**ADDENDUM
NO. 3**

**BOONE GROVE HIGH SCHOOL
RENOVATION AND RELATED WORK
Valparaiso, IN 46341**

ADDENDUM THREE

Addendum Three (AD.03) to the drawings and specifications prepared by Gibraltar Design for **Boone Grove HS Renovation and Related Work** for Porter Township School Corporation, Valparaiso, Indiana.

UNIT "B" ELECTRICAL FIRST
FLOOR DEMOLITION PLAN

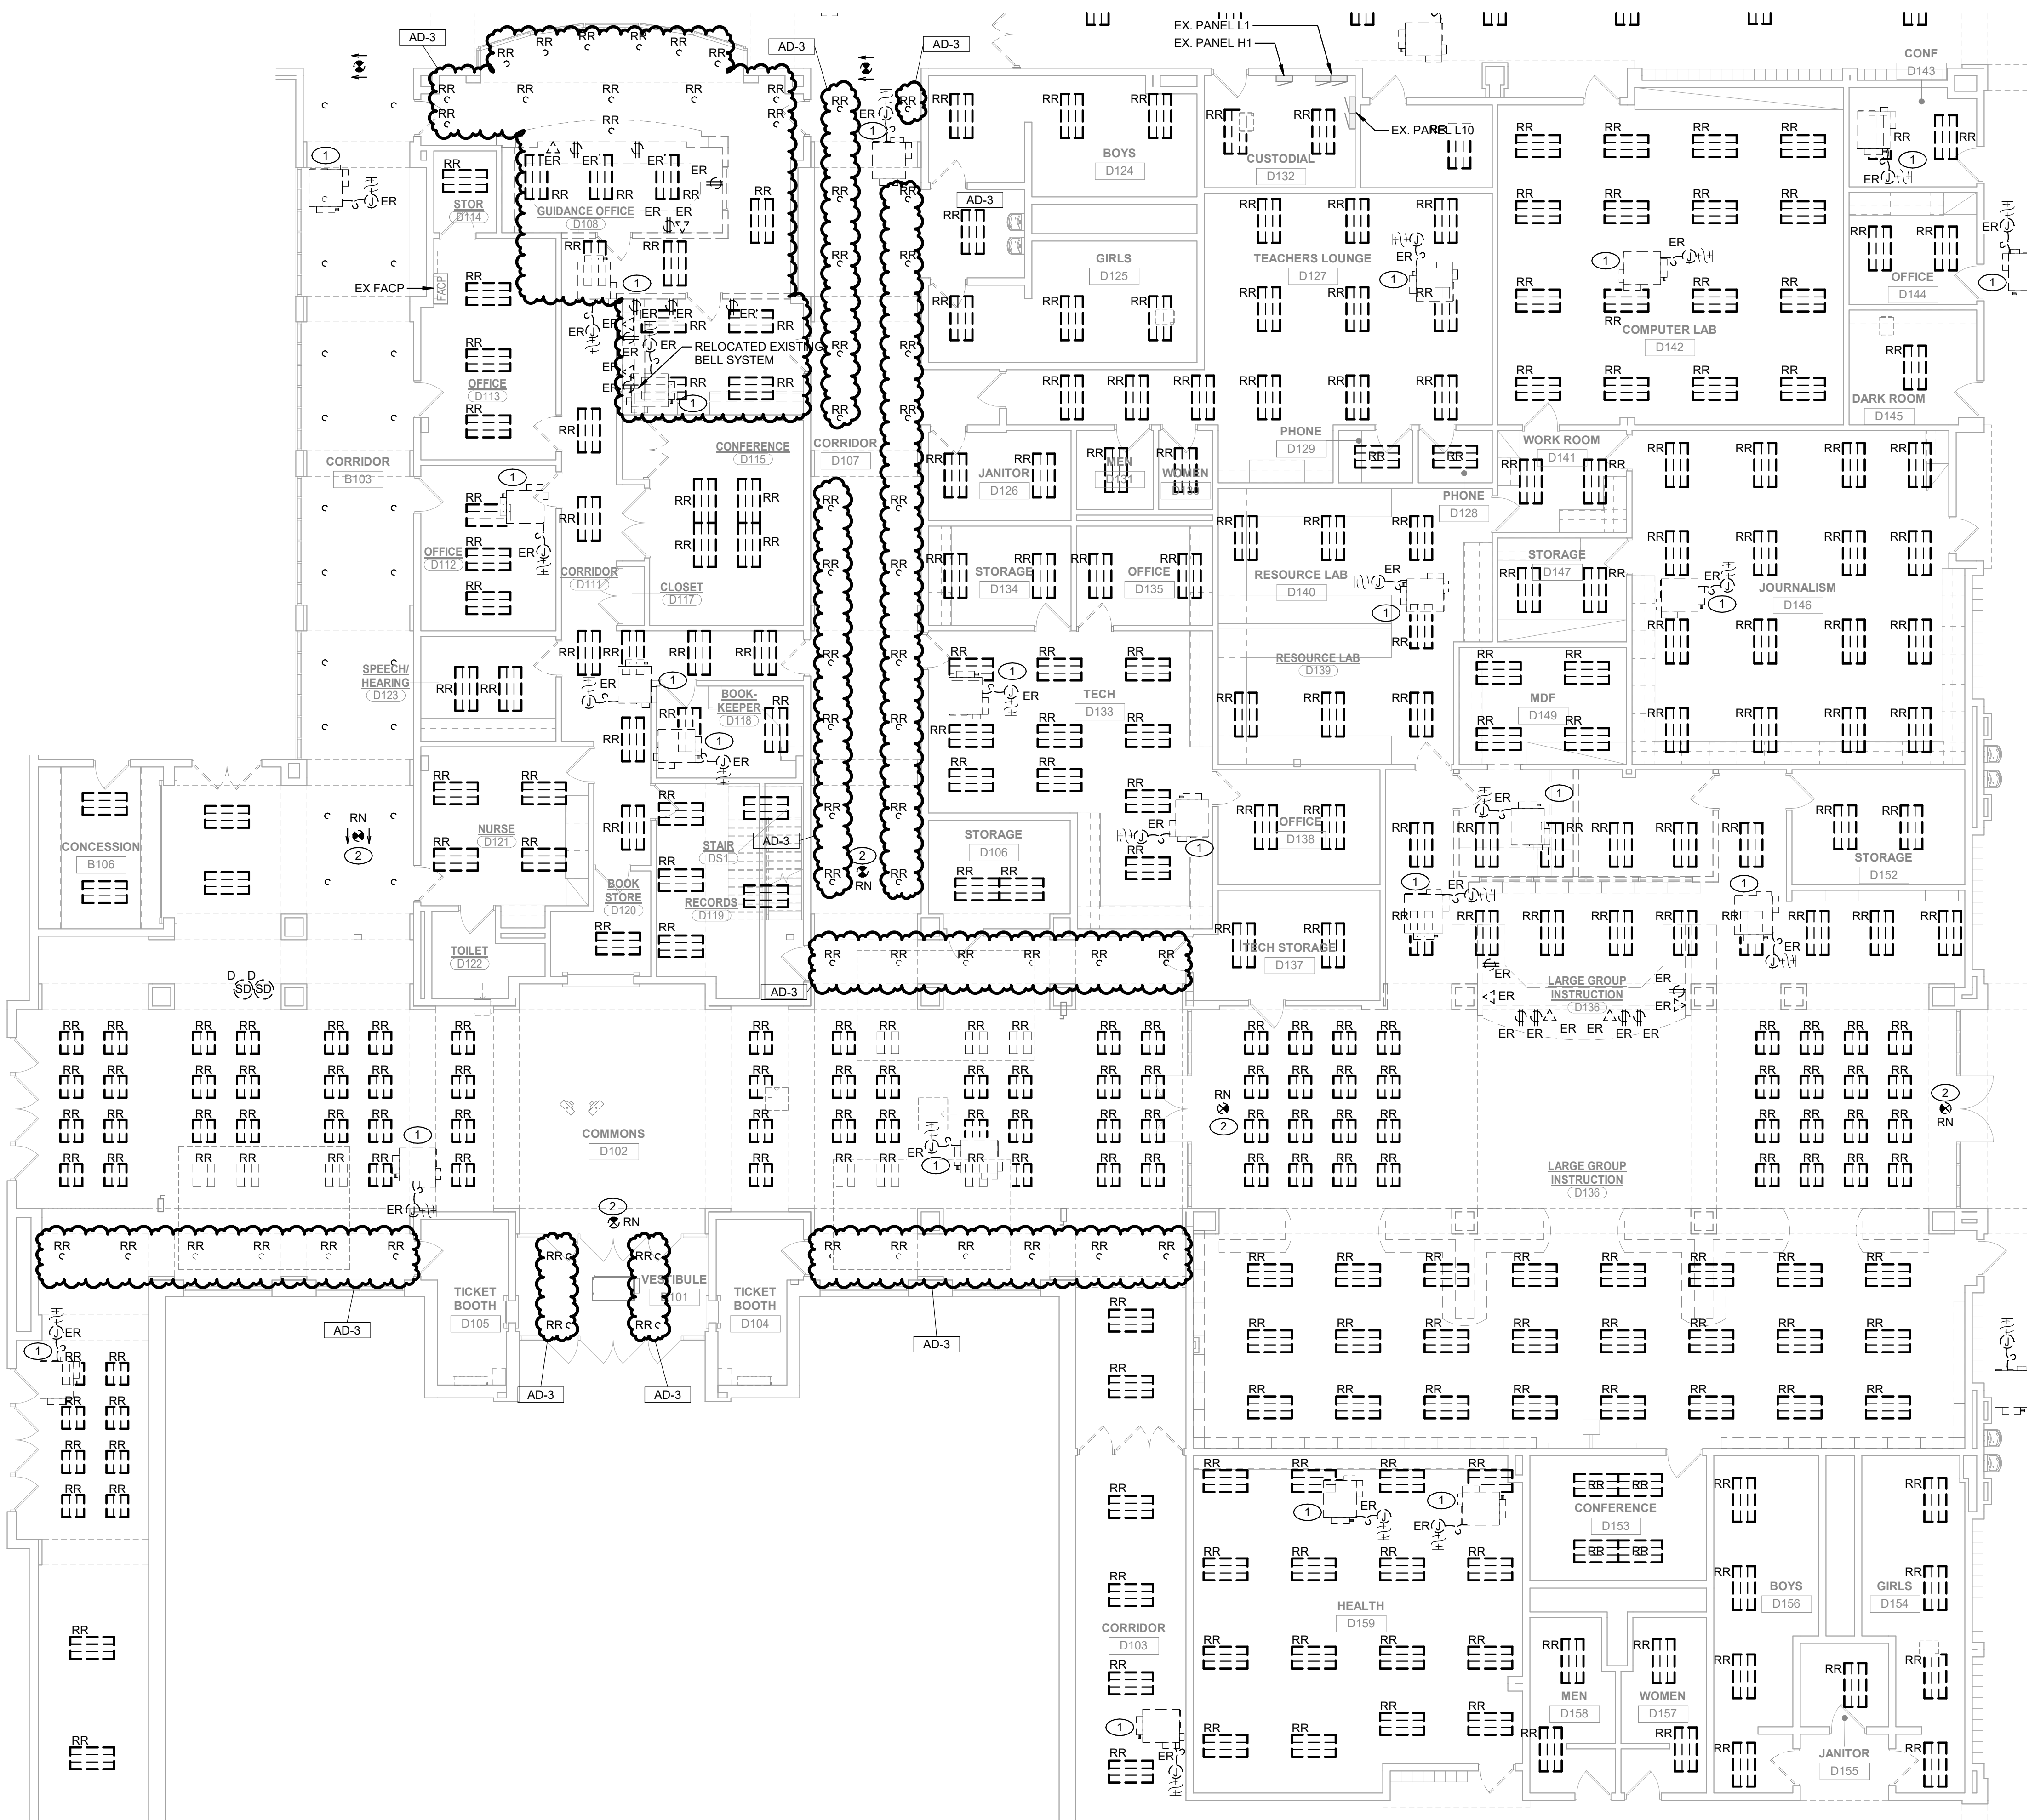
- A. Refer to revised, full-size drawing, included in this Addendum, for revisions.
 1. Added light fixtures to be removed and relocated.

UNIT "A" ELECTRICAL FIRST FLOOR PLAN

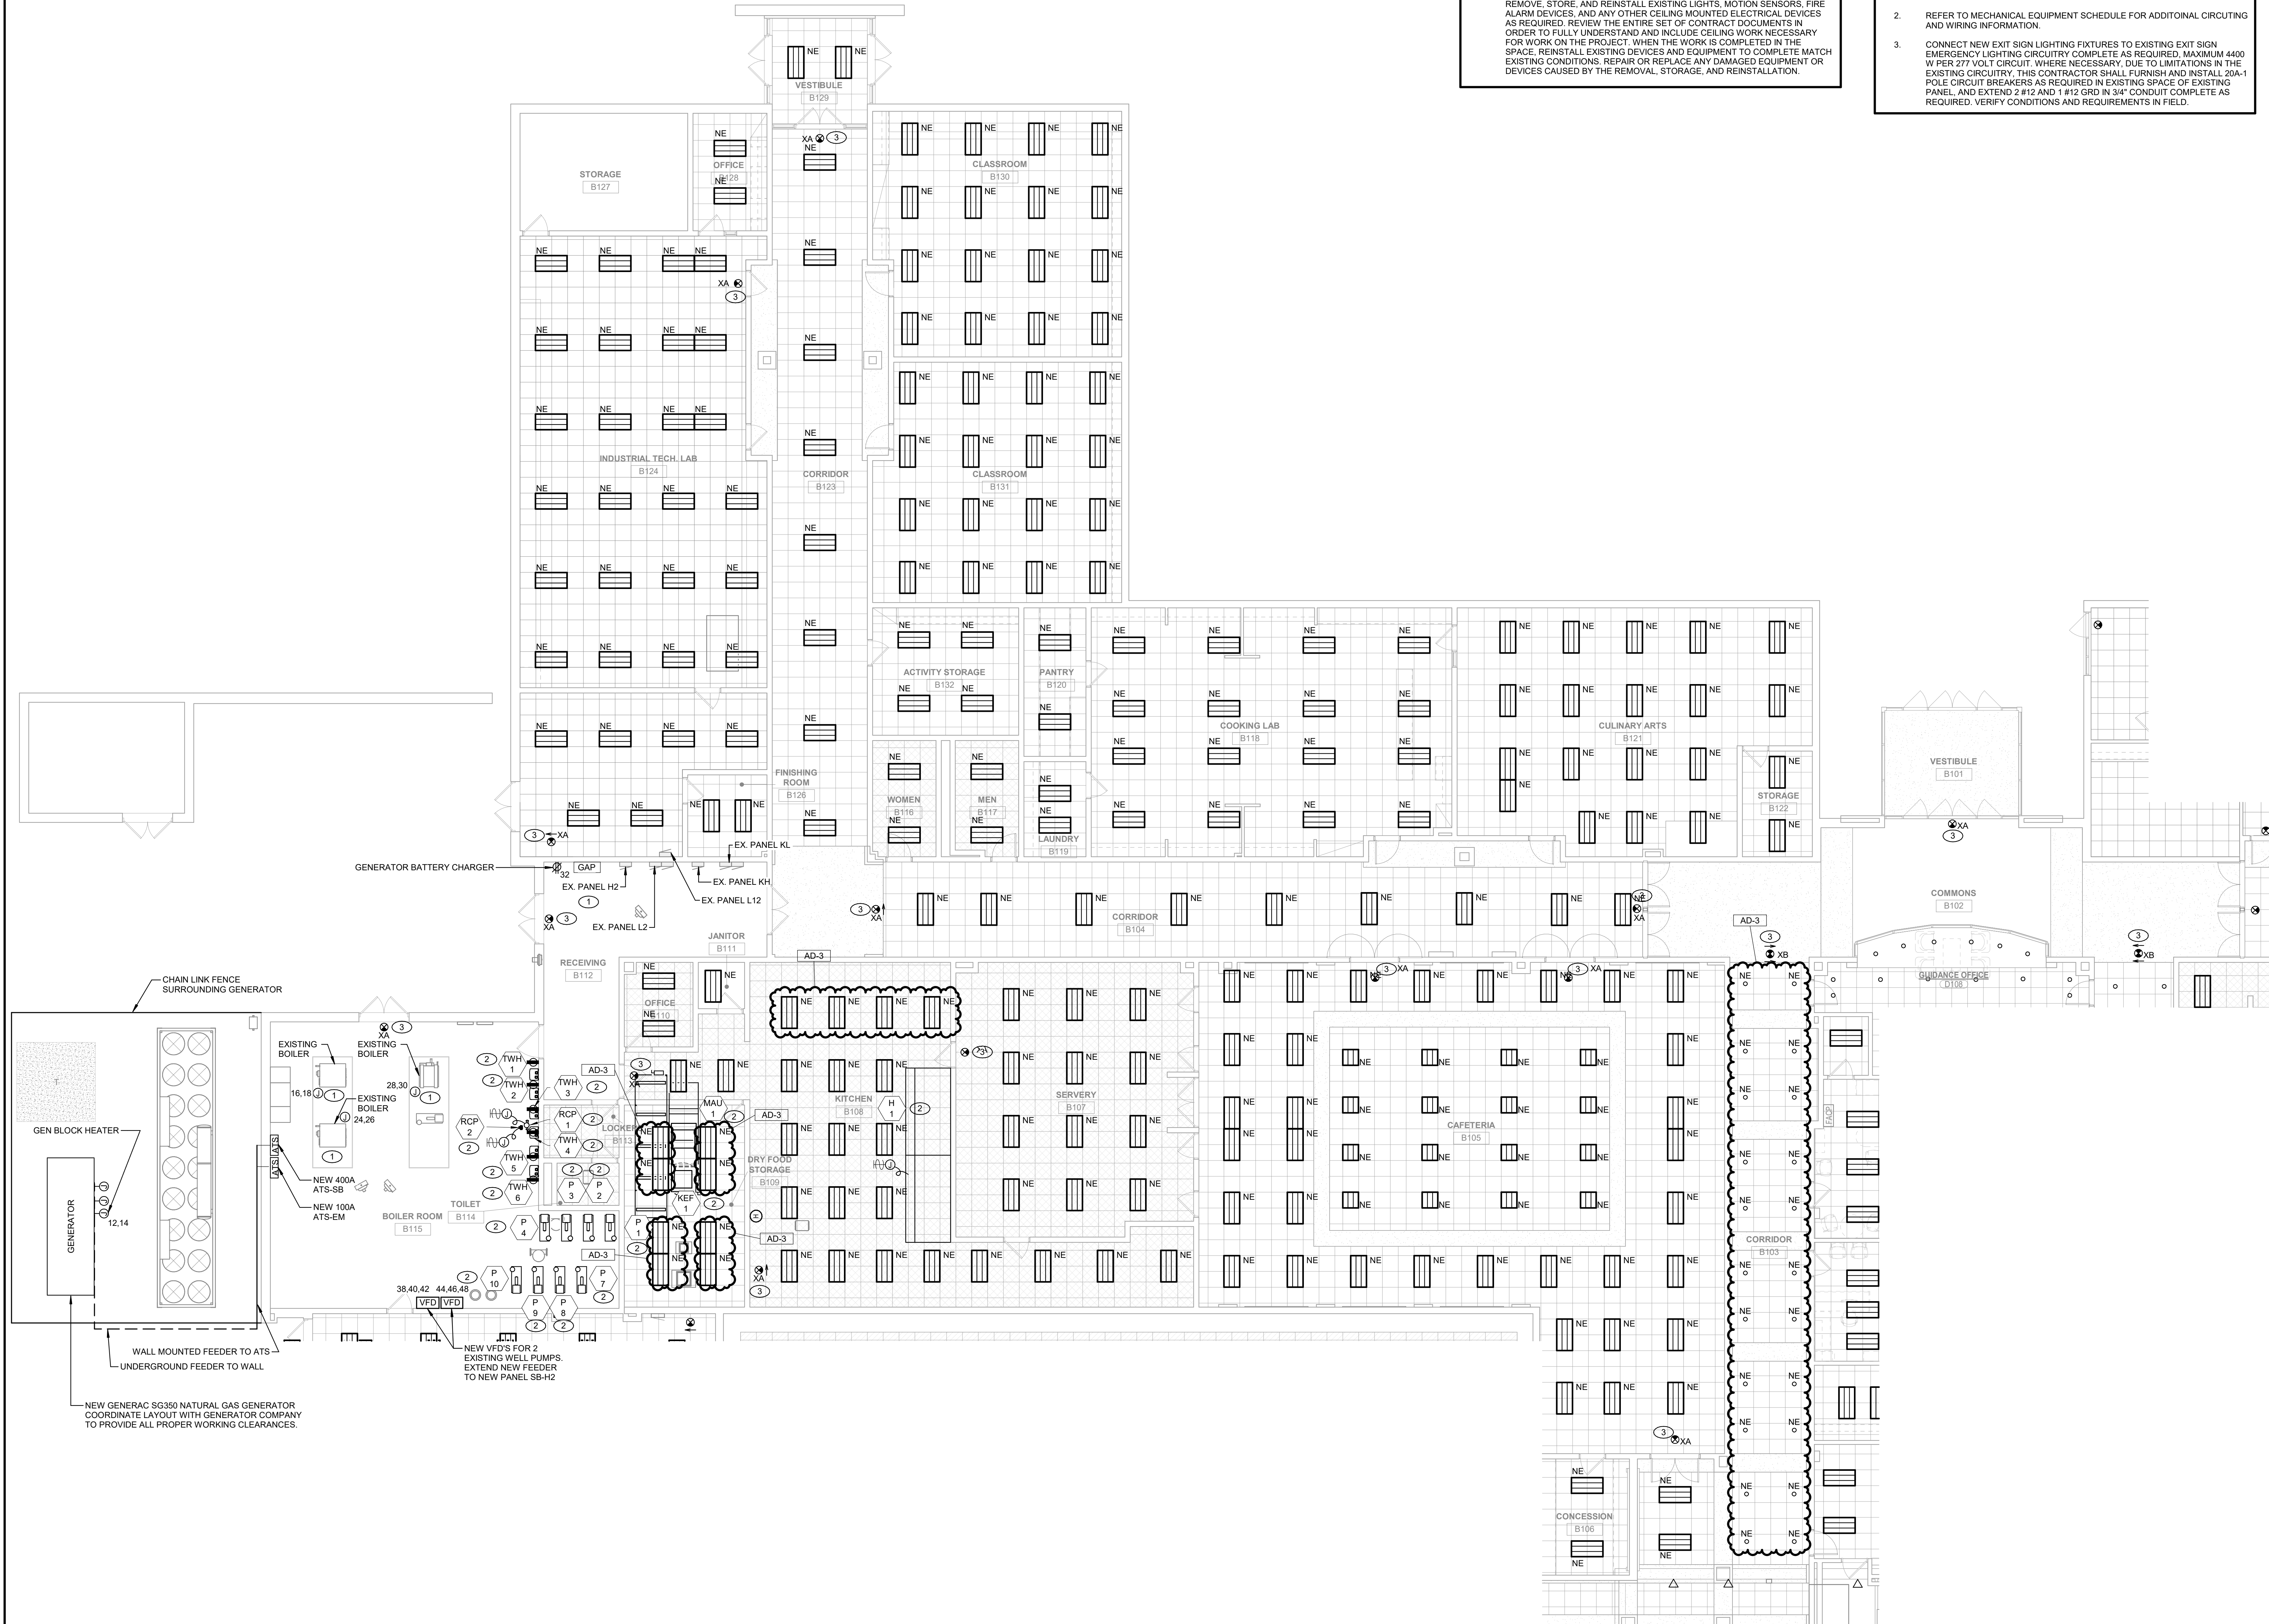
- A. Refer to revised, full-size drawing, included in this Addendum, for revisions.
 1. Added new locations for relocated light fixtures.
